STAFF REPORT: JULY 9, 2025 MEETING

APPLICATION NUMBER: HDC2025-0311

ADDRESS: 305 ELIOT

SCOPE: REPLACE SLATE DORMER SIDING (WORK COMPLETED WITHOUT APPROVAL)

East side wall. Staff photo, June 25, 2025.

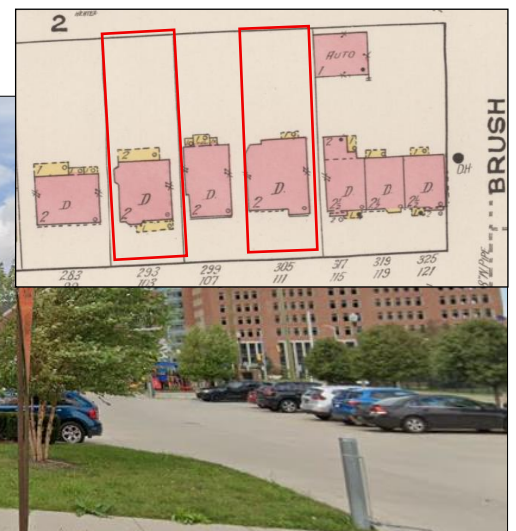
The dwelling's three chimneys (two at the east wall, one at the west wall) have multiple corbels, and the east-facing dormers have flared hip roofs. The rear addition was erected circa 1994 (HDC94-094).
